SUBJECT: Response to Site Investigation Work Plan, Interim Site Investigation Report, Conceptual Site Model and Aerial Deposition Evaluation Report
JCI/Tyco Stanton (PFAS), 1 Stanton Street, Marinette, WI
BRRTS #02-38-581955

Response to Site Investigation Work Plan Interim Site Investigation Report,
 Conceptual Site Model and Aerial Deposition Evaluation Report
 BRRTS #02-38-581955

FIGURE 8

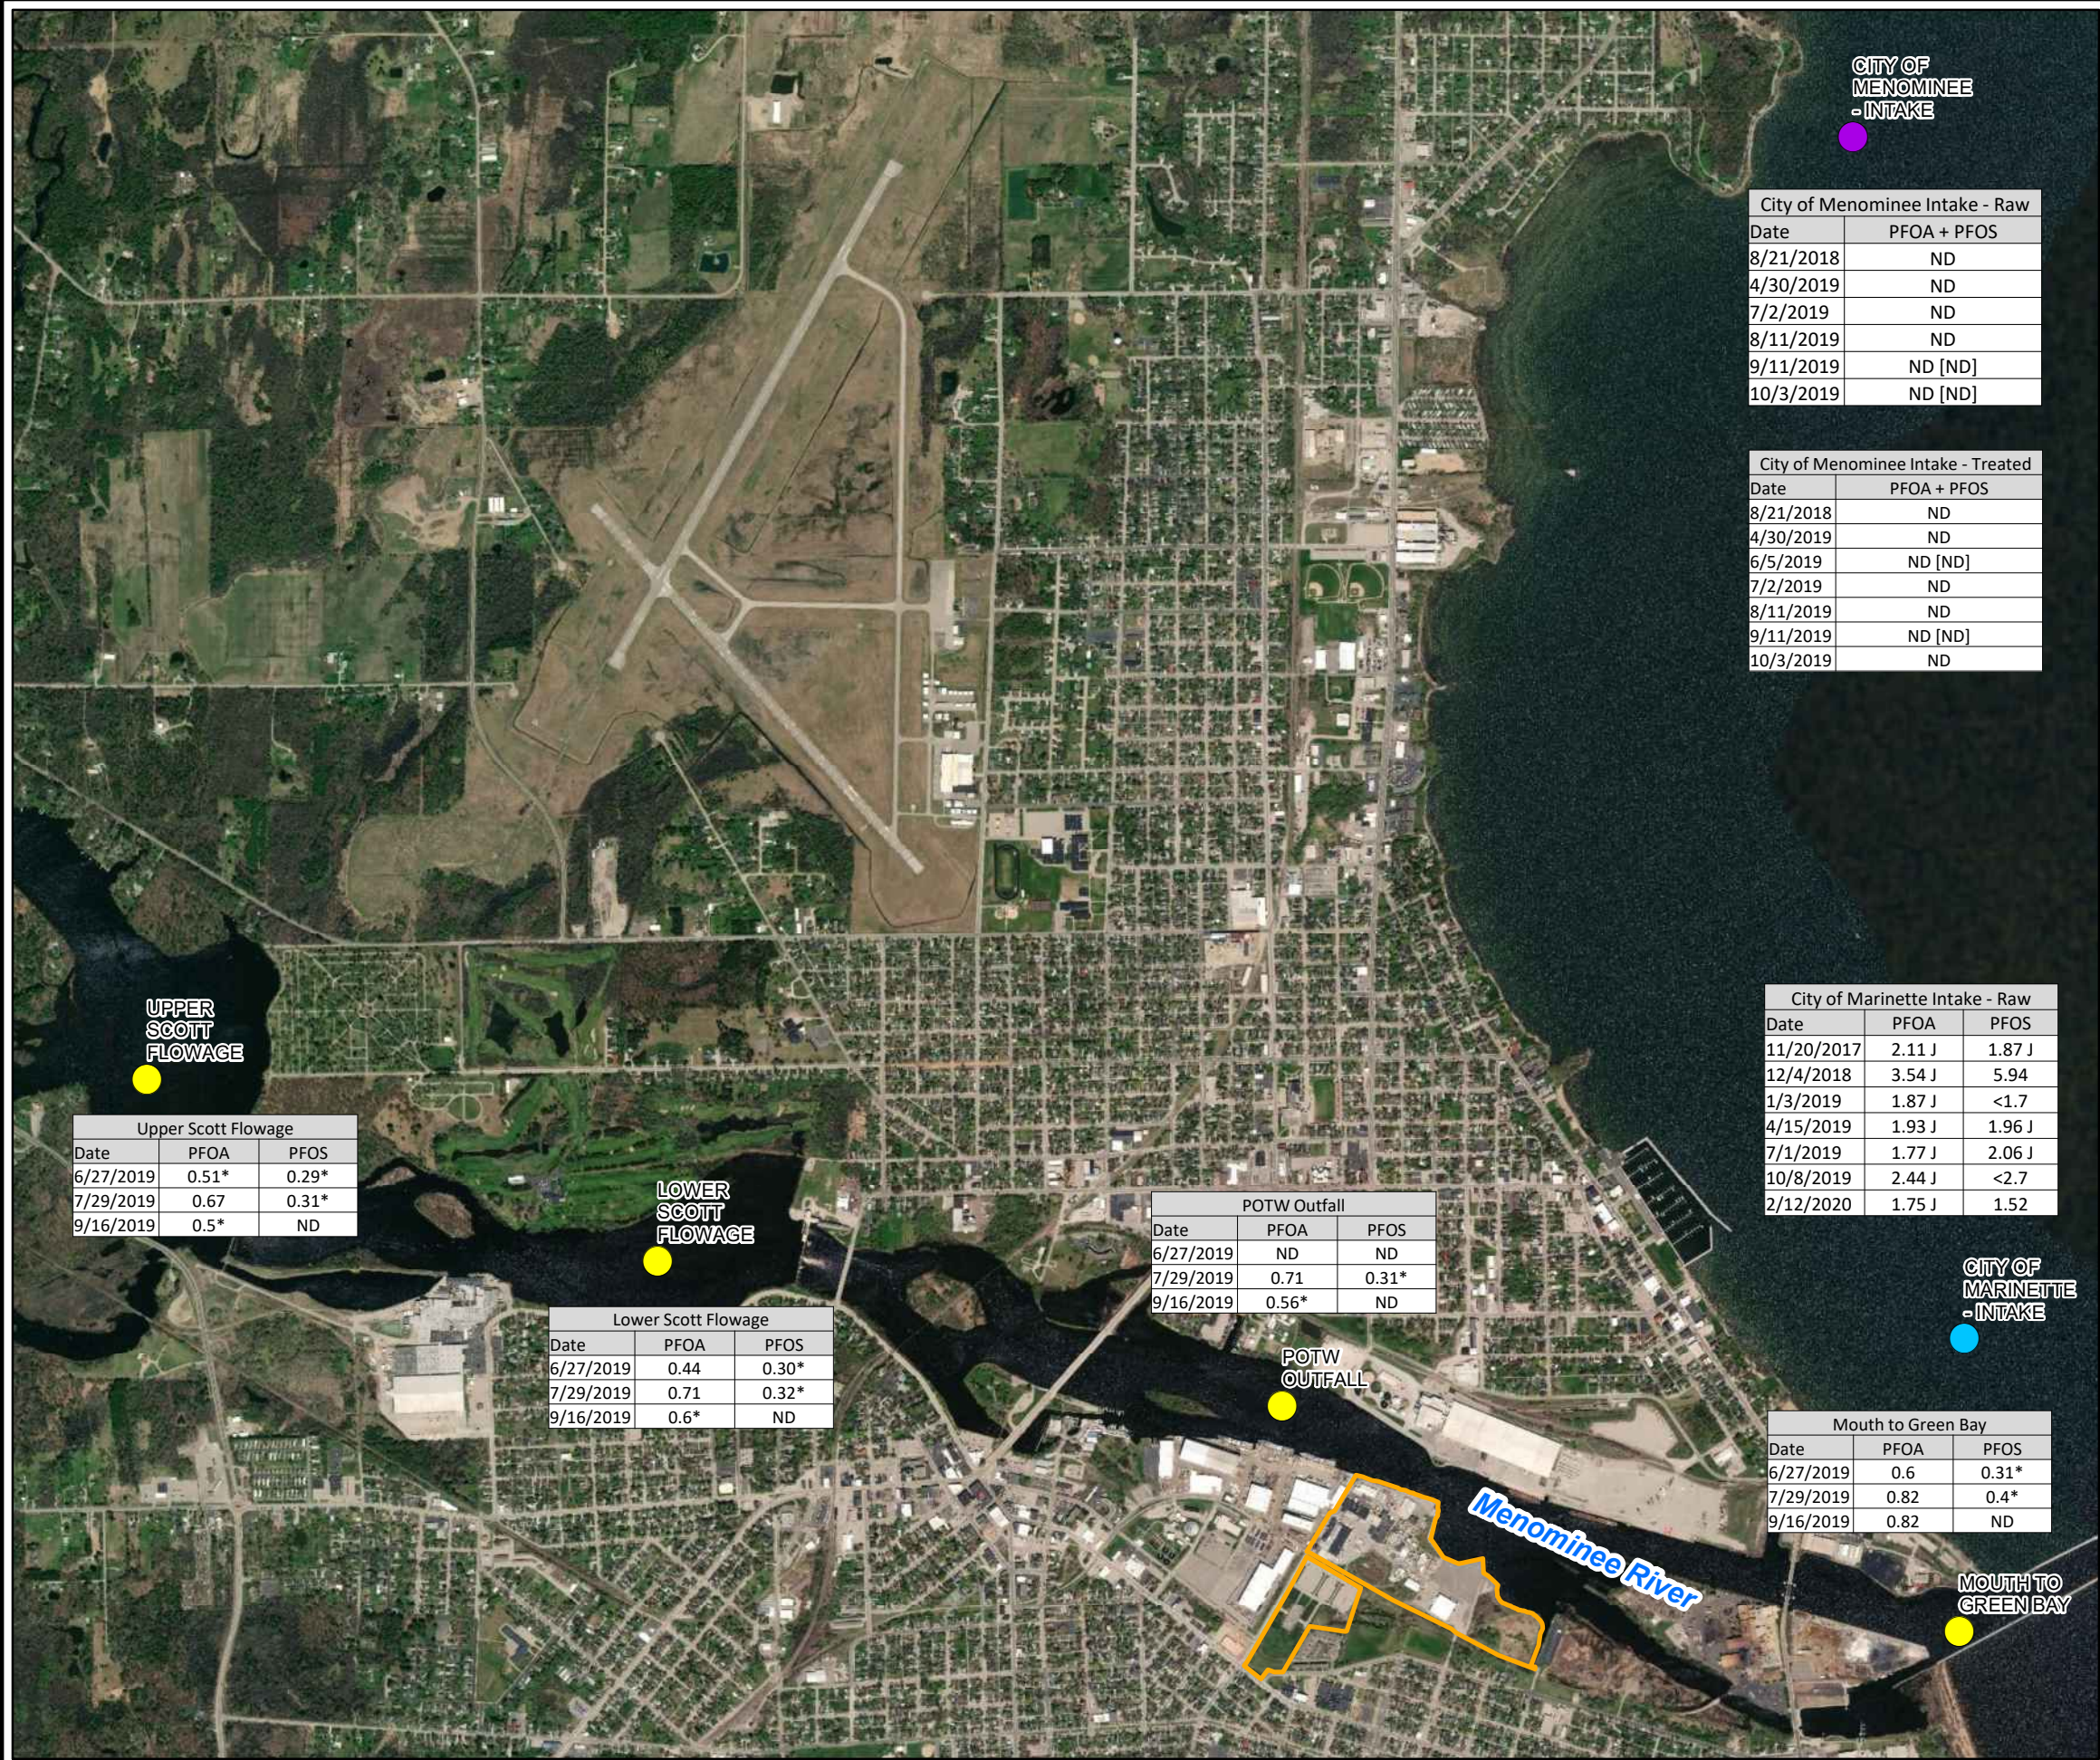
JCI/Tyco collected soil samples from seven locations and groundwater samples from 18 existing on-site monitoring wells. The sample locations are shown on Arcadis' Figures 5 and 8 in **Attachment A**. These samples were analyzed for 14 PFAS compounds. The results for PFOA and PFOS are summarized in the tables below; other PFAS were also detected.

FIGURE 2
SITE MAP WITH
BARRIER WALL DETAILS
 TYCO FIRE PRODUCTS LP
 MARINETTE, WISCONSIN

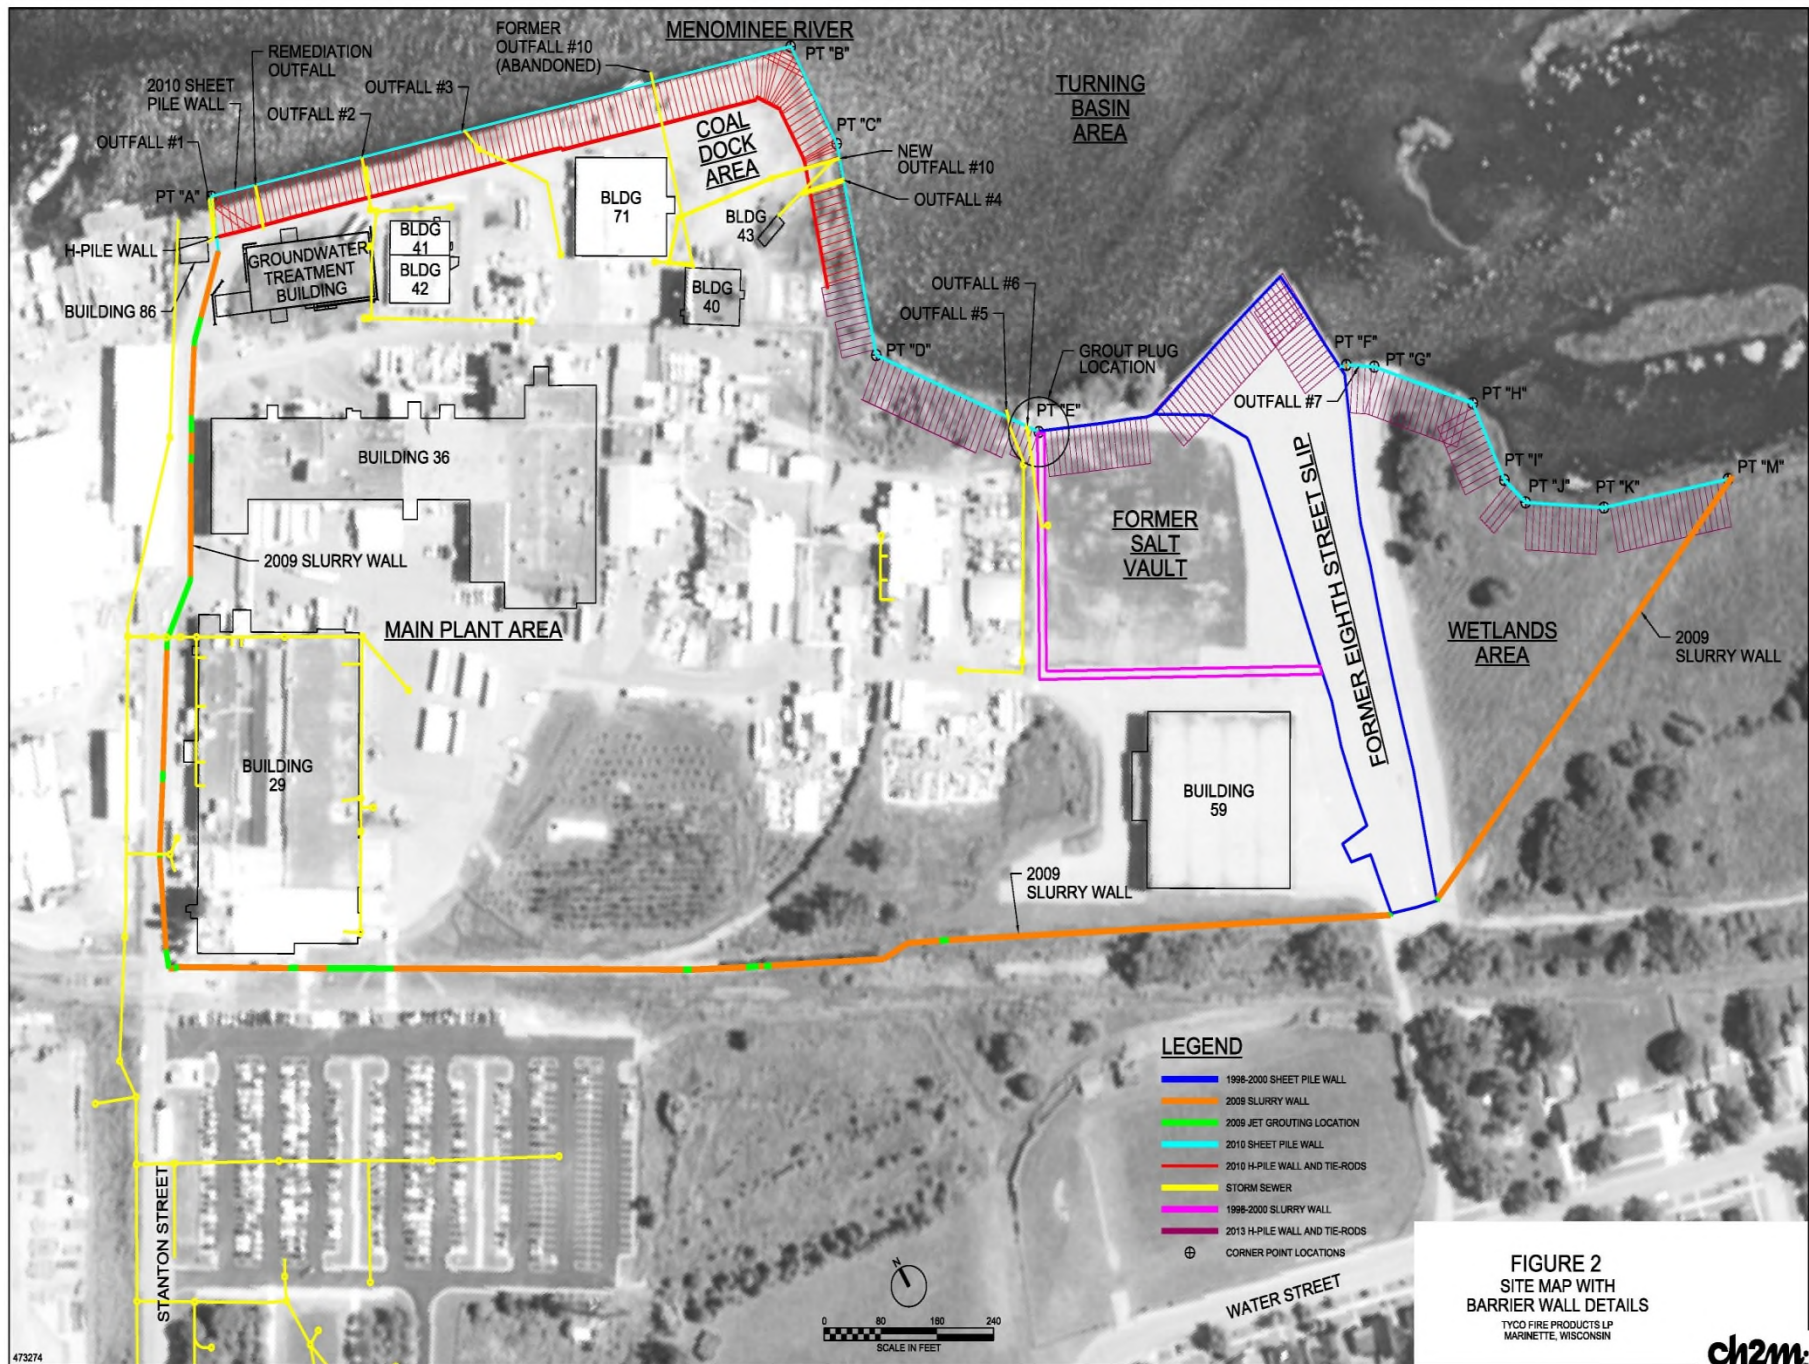
JCI/Tyco included a map of seven stormwater outfalls at the bulkhead along the Menominee River (see CH2M Hill Figure 2 in **Attachment A**). JCI/Tyco indicated that this was a partial map for the stormwater management and that JCI/Tyco will update the stormwater management on the Site to be above ground by January 1, 2023.

Data Gap #4a: Maps identifying all historical and current stormwater flow and discharge locations, and the plans for the above-ground stormwater management when the plans become available.
